Historic Landmarks Committee
Community Development Center, 231 NE 5th Street
July 25, 2018 3:00 PM

EXHIBIT 1 - STAFF REPORT

DATE: July 25, 2018
TO: Historic Landmarks Committee Members
FROM: Chuck Darnell, Senior Planner
SUBJECT: HL 8-18 / DDR 8-18 – 337 NE Baker Street

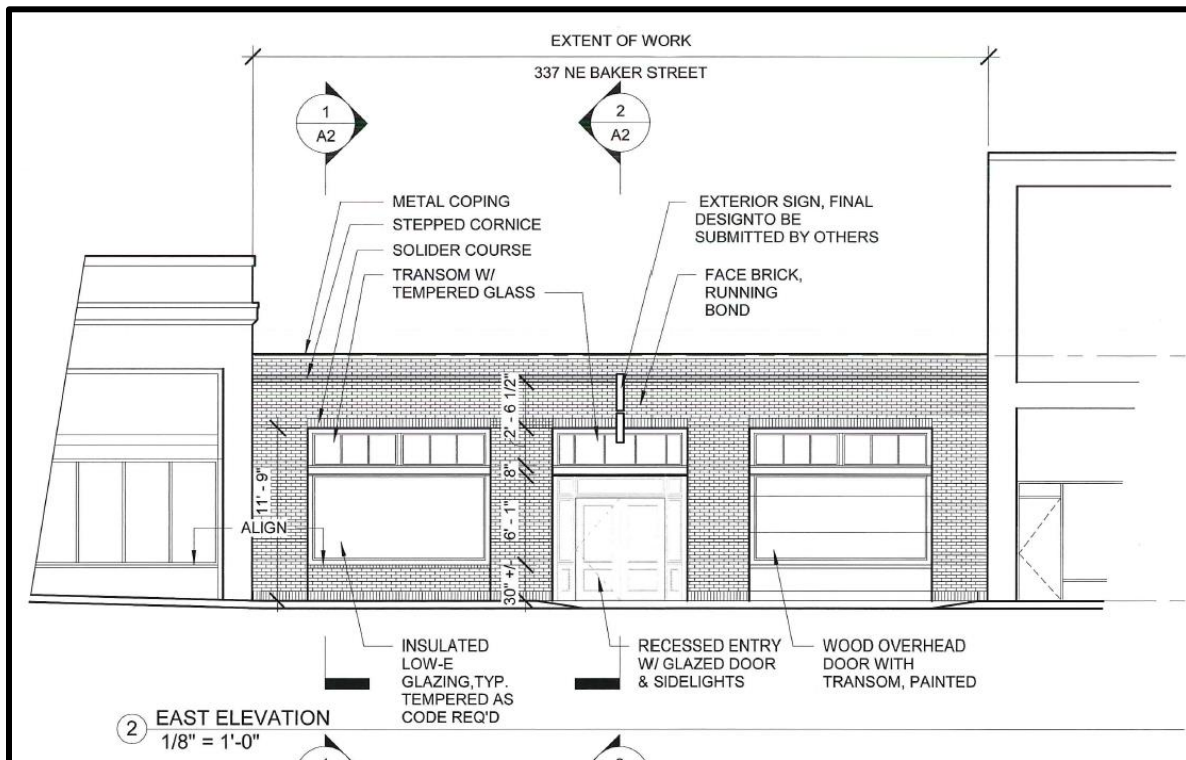
The proposed design meets most of the applicable storefront standards, other than the minimum 70 percent glazing requirement, which the applicant is requesting a design waiver from. That design waiver request will be discussed in more detail below.

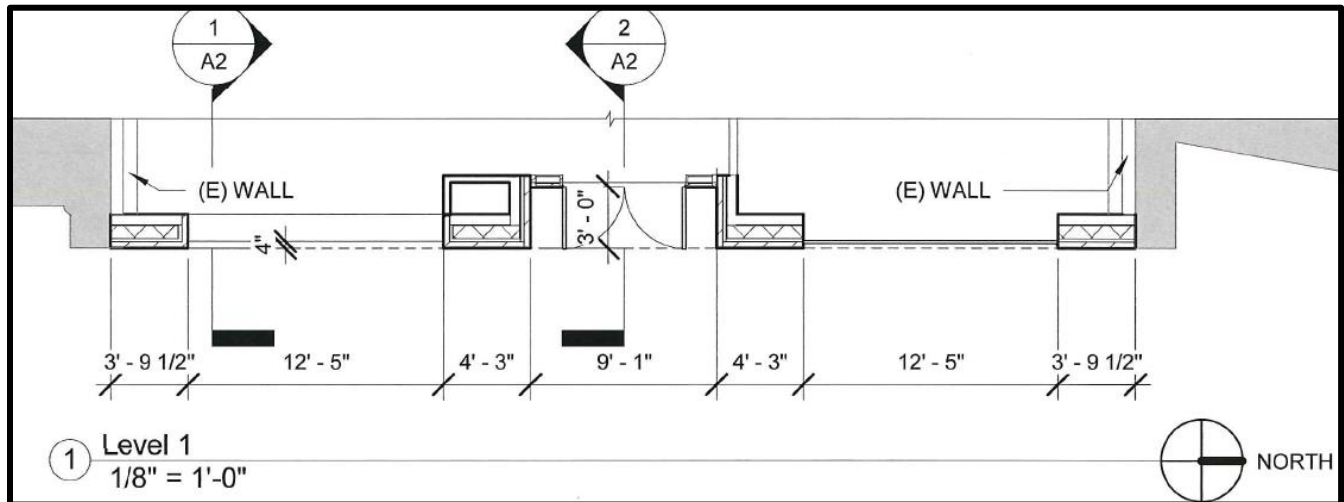
The proposed alterations will not change the roof lines of the original structure, which is flat and consistent with the rooflines of adjacent buildings.

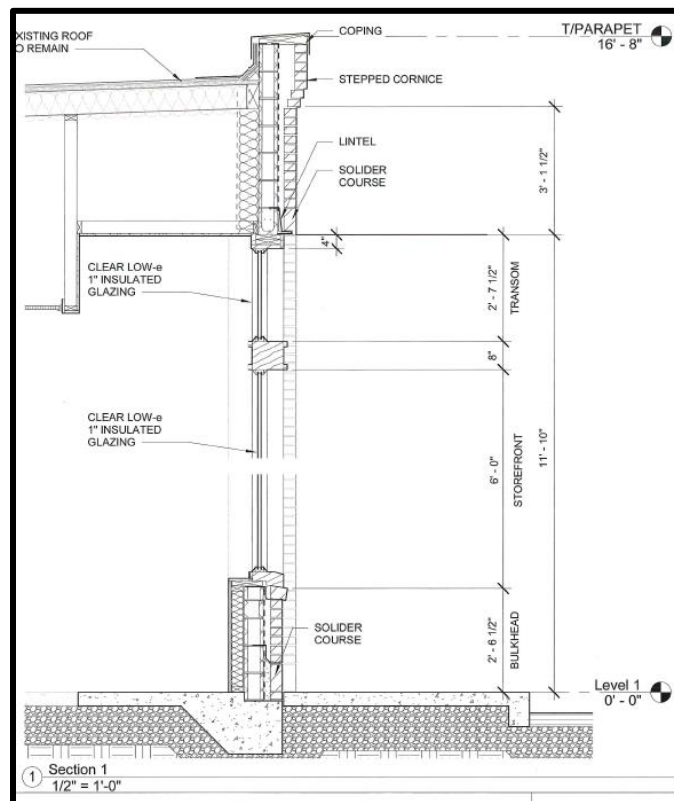
The proposed design includes the relocation of the primary entrance to the building to the center bay, consistent with the historic design of the building as documented in a circa 1940s photograph of the building. The entrance will be recessed three feet, and will open on to the public right-of-way as the building is constructed with a zero setback up to the property line. The recessed entry can be seen below:

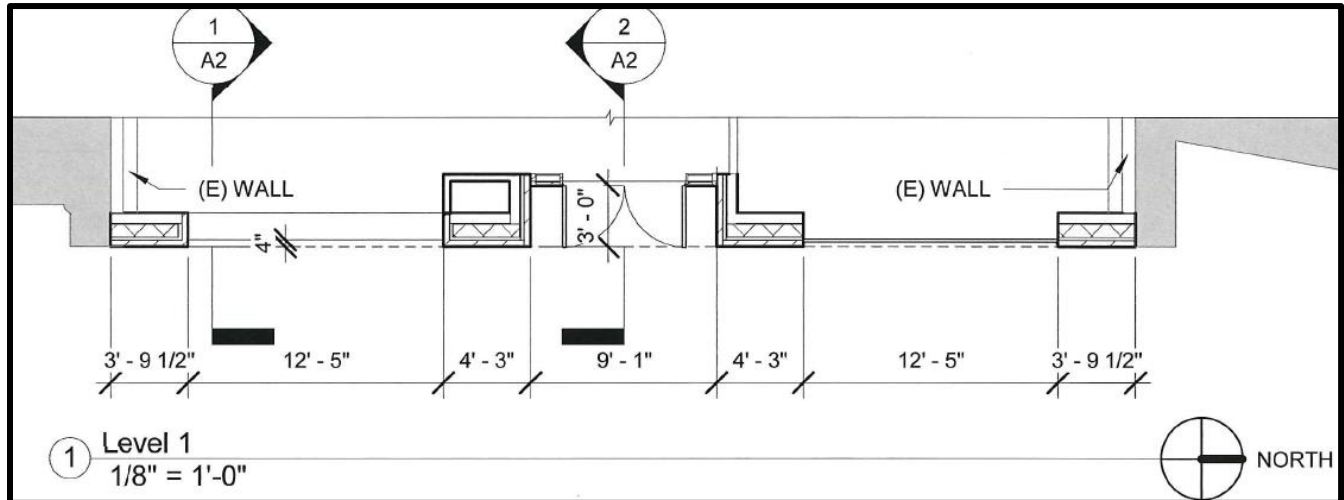
The windows are proposed to be recessed by 4 inches from the outer wall. The recessed windows are shown in the drawings below:

A1

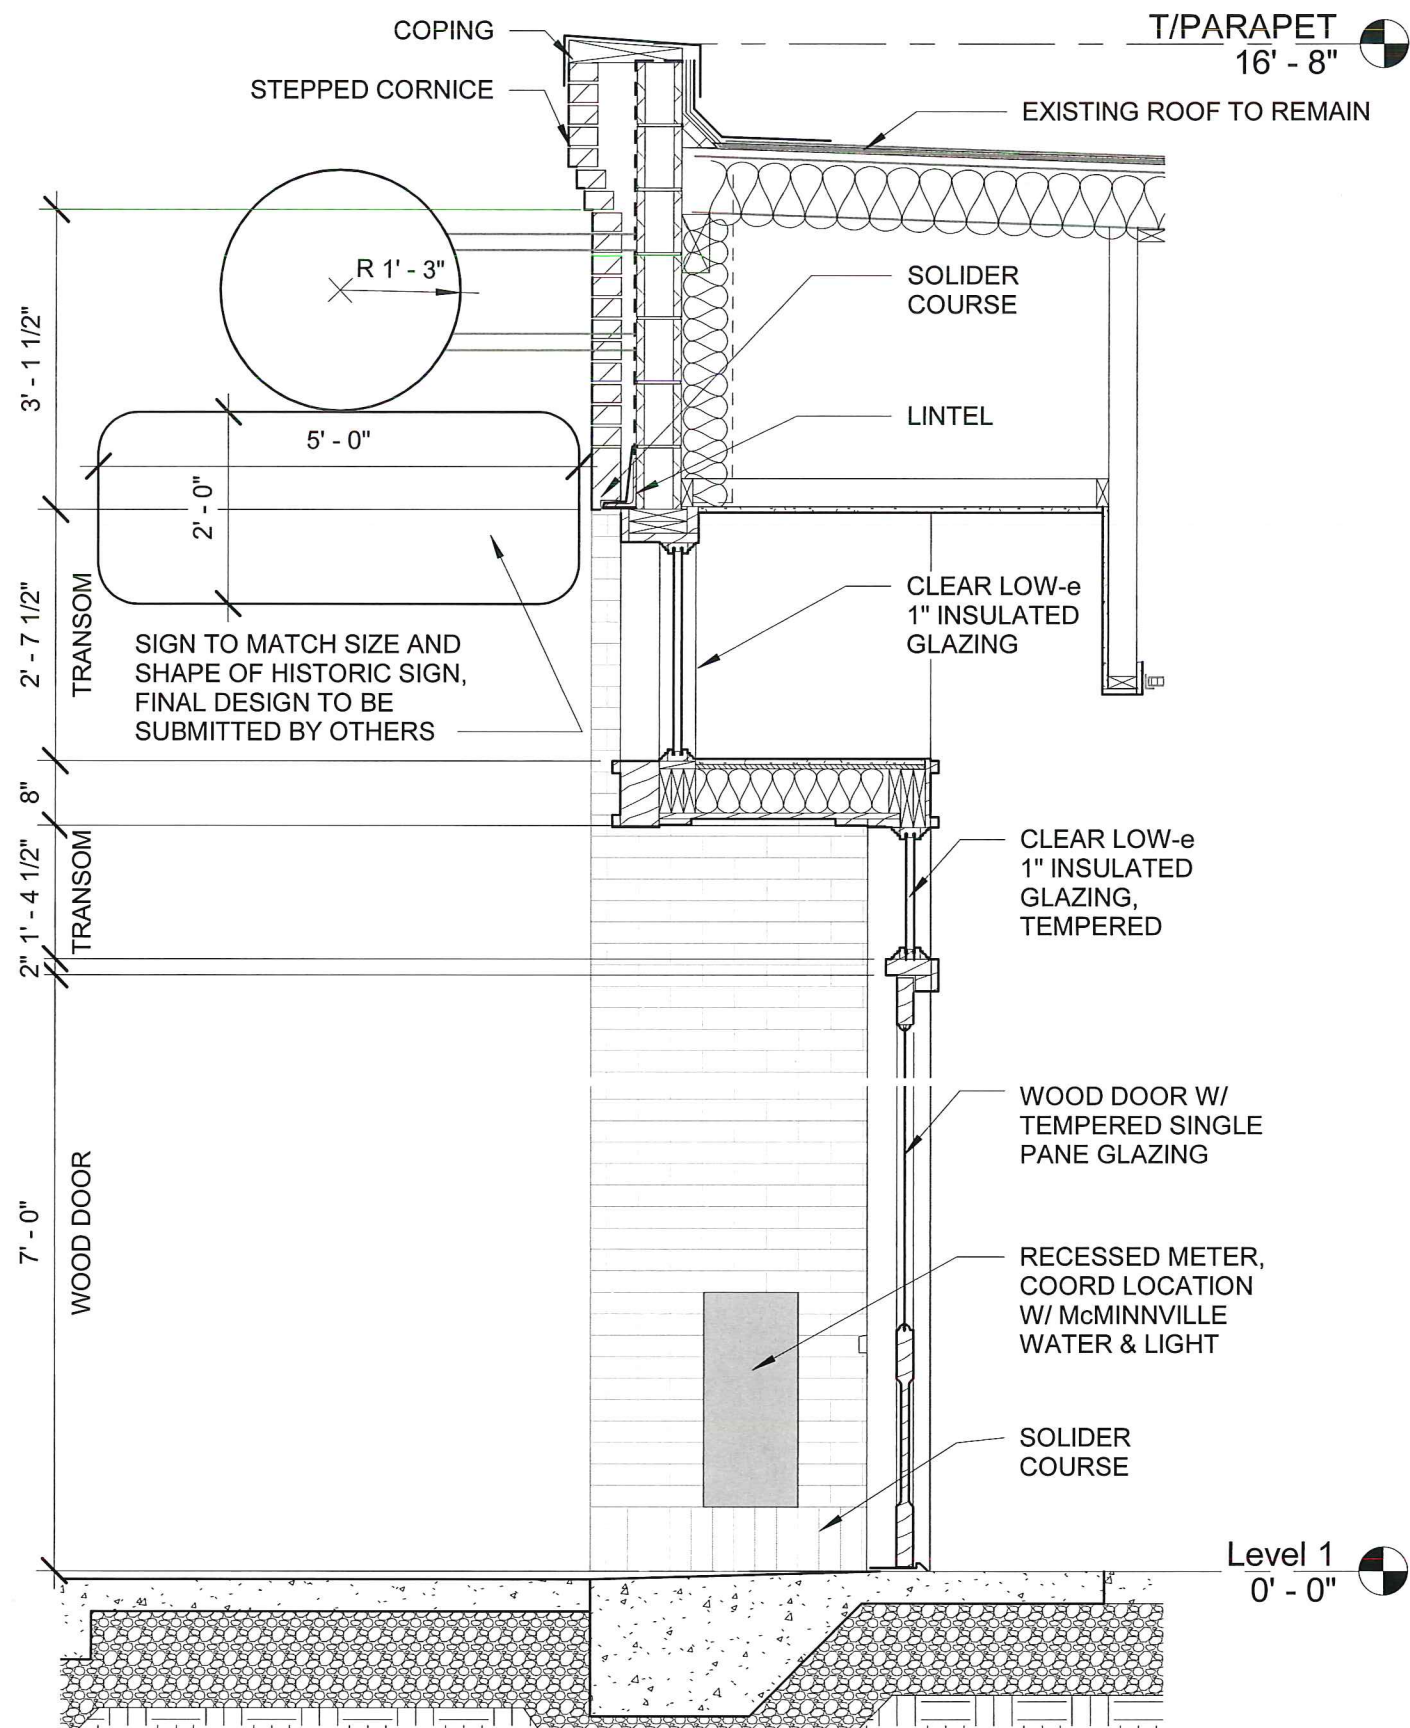
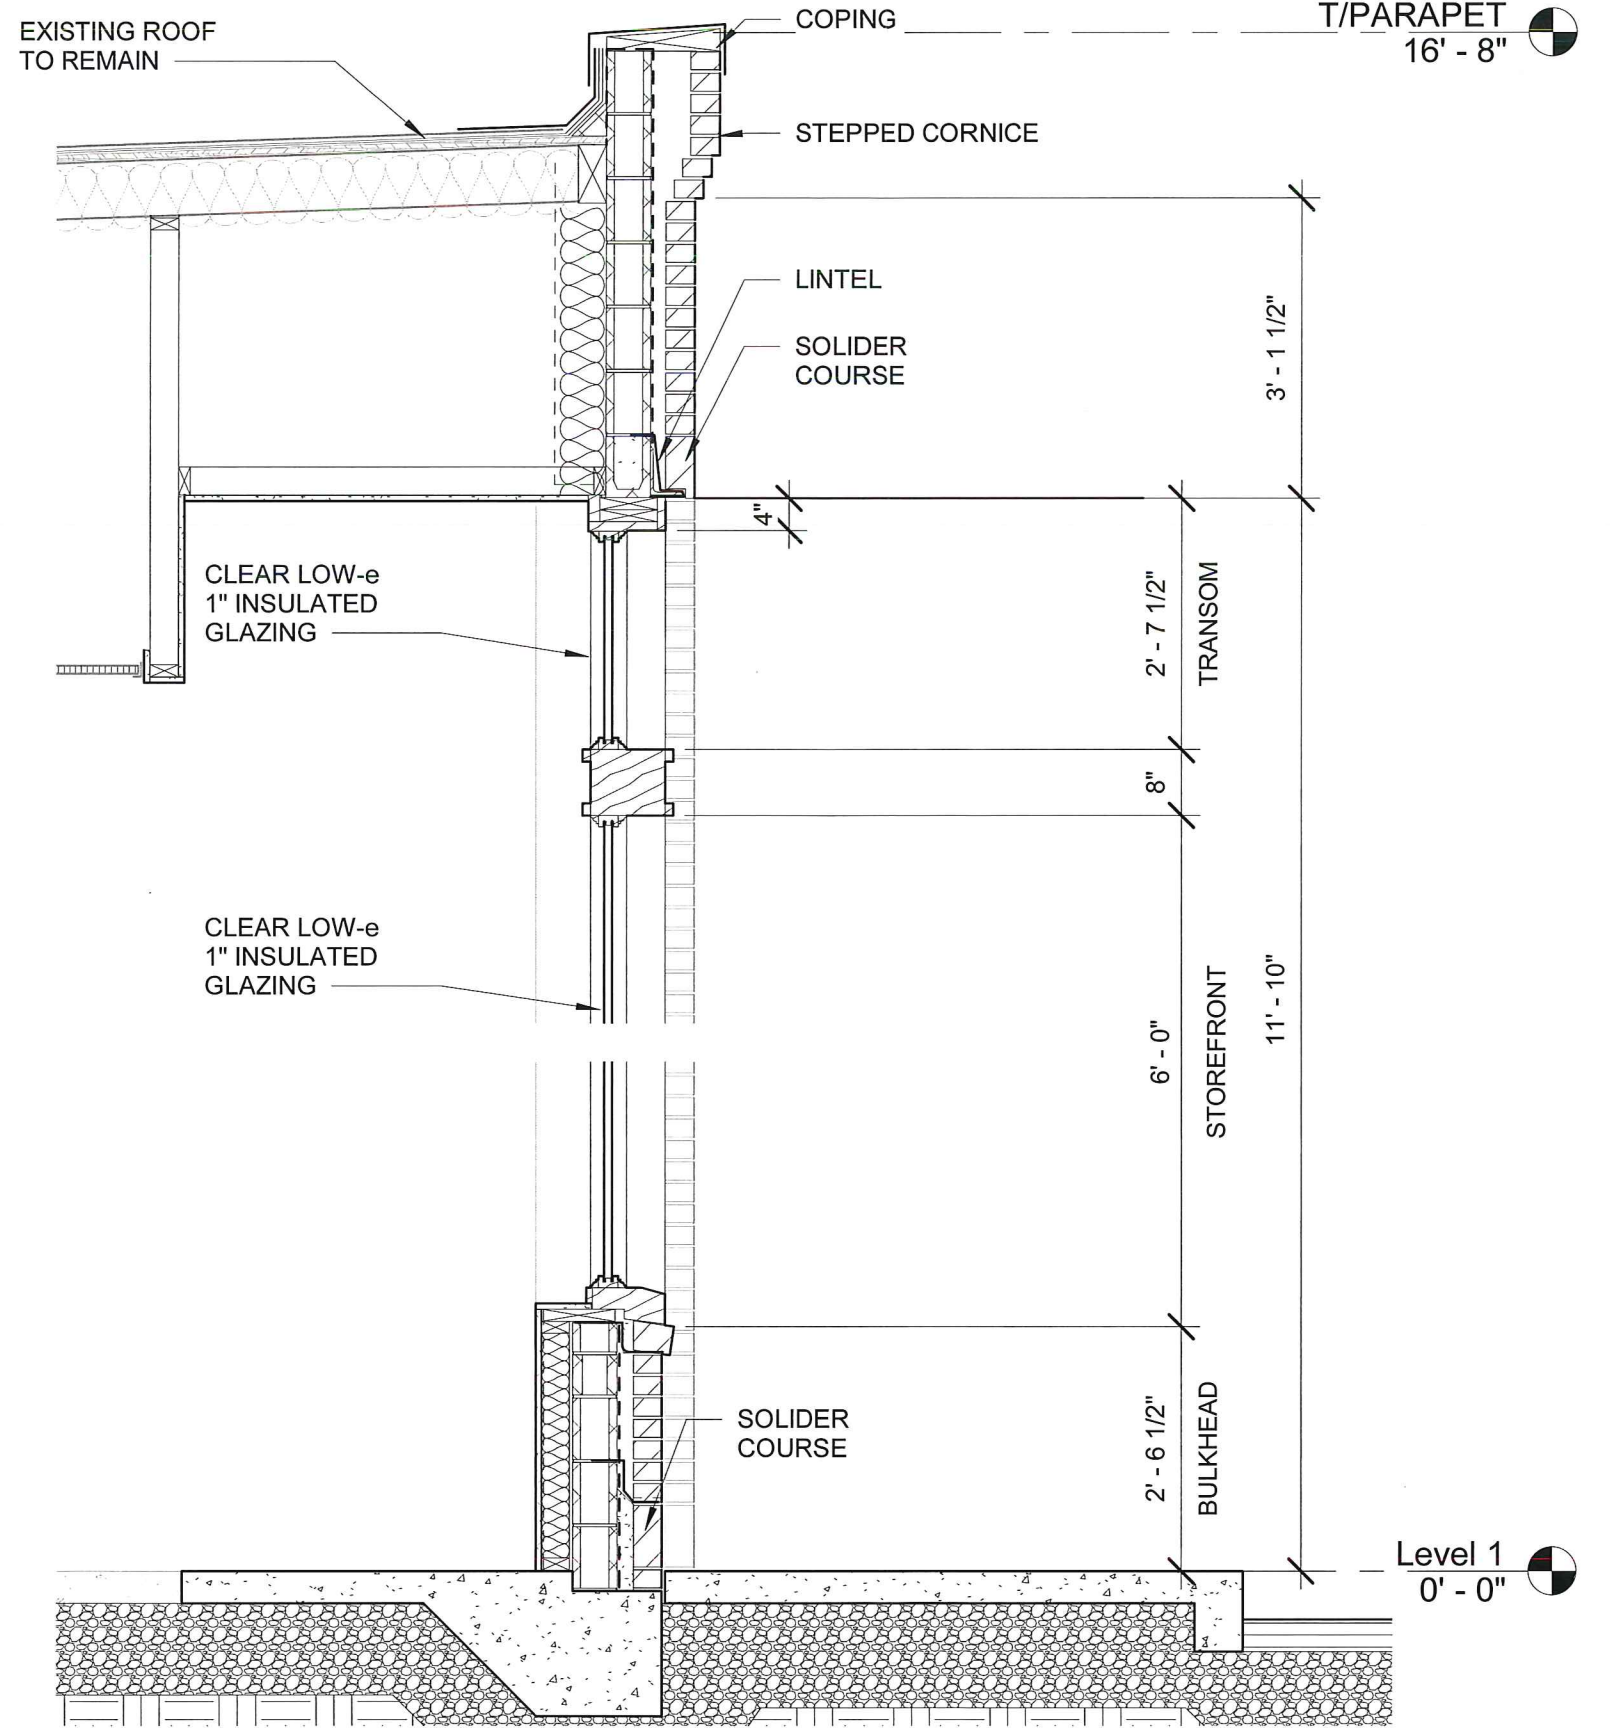
Finding: This requirement is met. No change to roof line, refer to architectural elevation in Exhibit E, sheet A1.

Finding: This requirement is met. The windows are recessed with in the 3 bays, refer to architectural elevation in Exhibit E, sheet A1.
Building is one story so upper floor window orientation is not applicable.

Finding: This requirement is met. The building's base will be brick veneer, refer to architectural elevation in Exhibit E, sheet A1.

A2

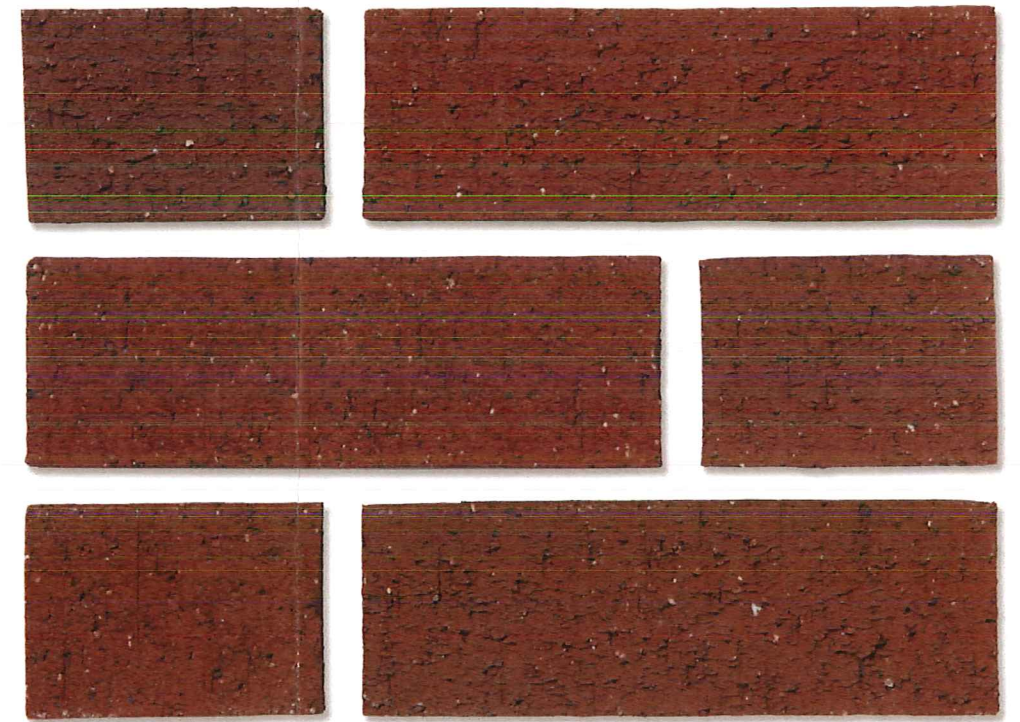
Finding: This section is met. A building mounted sign, replicating the historic character, form, materials and size illustrated in the 1940s photograph will be located above the Main entry, Refer to Exhibit E, sheet A2 for sign design.

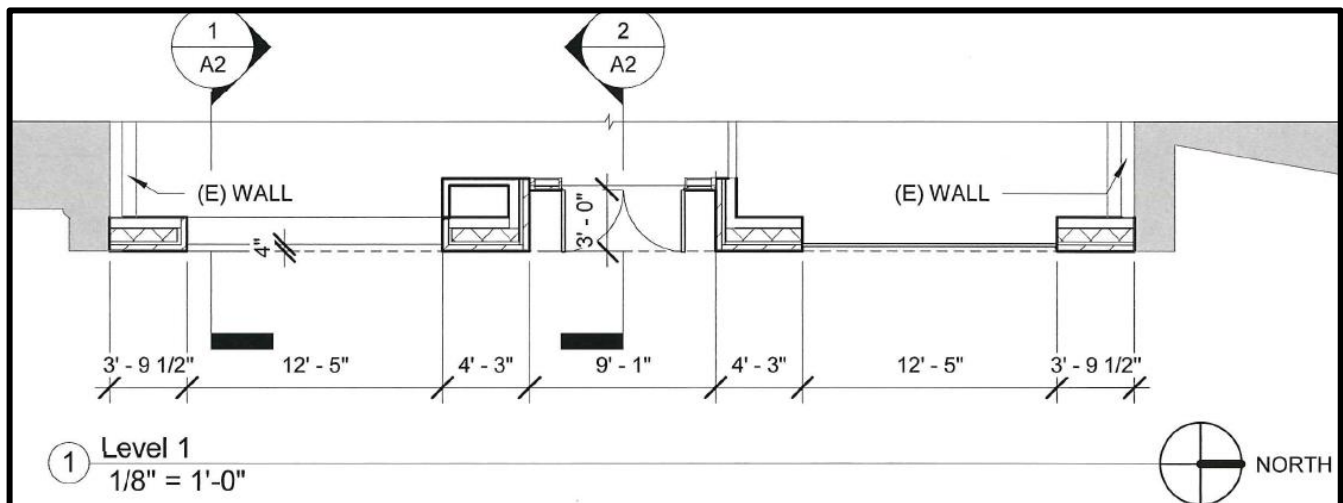
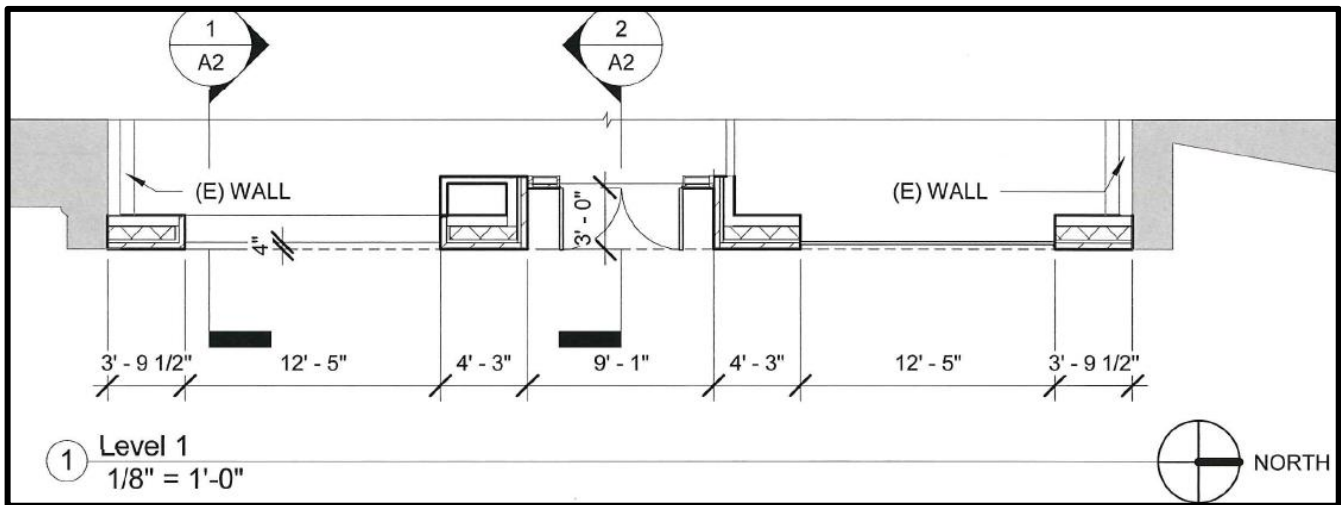
Finding: The proposed alterations will not change the roof lines of the original structure, which is flat and consistent with the rooflines of adjacent buildings.

Finding: The proposed design includes the relocation of the primary entrance to the building to the center bay, consistent with the historic design of the building as documented in a circa 1940s photograph of the building. The entrance will be recessed three feet, and will open on to the public right-of-way as the building is constructed with a zero setback up to the property line. The recessed entry can be seen below:

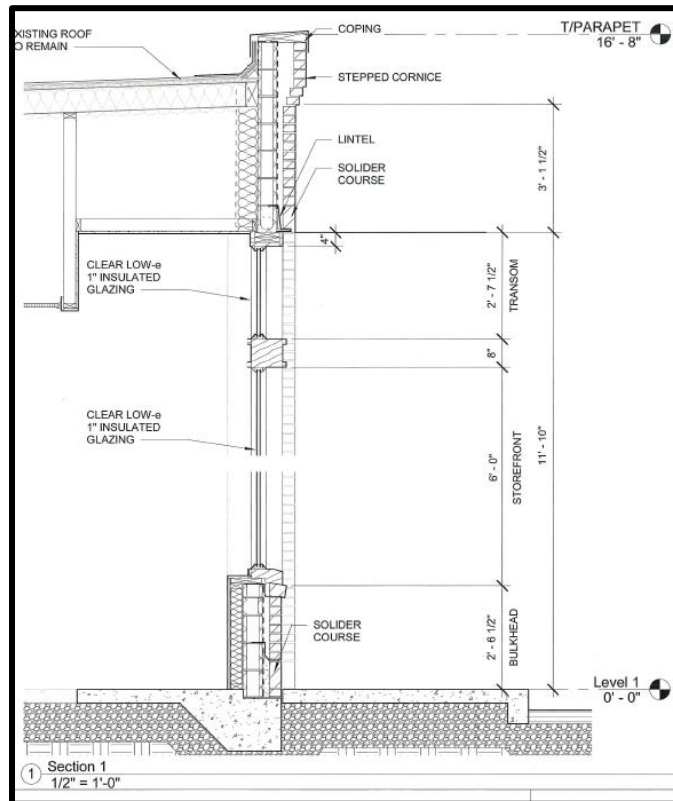
Finding: The windows are proposed to be recessed by 4 inches from the outer wall. The recessed windows are shown in the drawings below:
